FAQ Number 13-0006 FAQ Revision 0

FAQ Title Modeling Junction Box Scenarios in a Fire PRA

Plant: Various Date: May 6 2013

**Figure 14:** Layout of physical analysis units used in the conceptual example

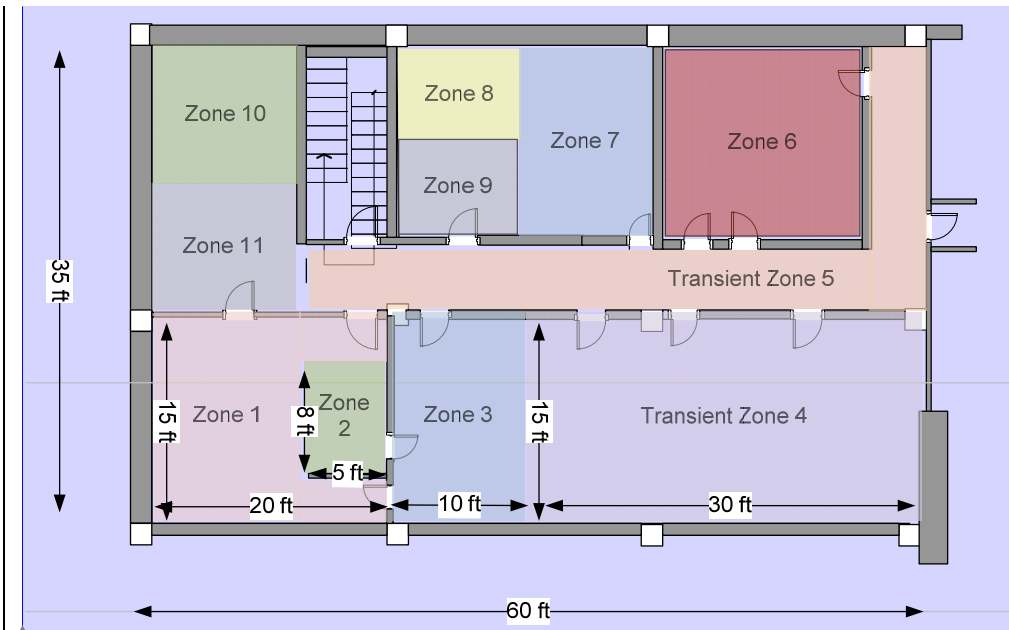
Comment [J7]: Ditto with earlier remarks on using the transient approach.

**Comment [J8]:** Many of this is related to the transient zone and needs to be changed. Transient zone is not a general term in PRA, and is not generally applied in PRAs.

**Comment [J12]:** Figure no longer appropriate since not using transient zones.
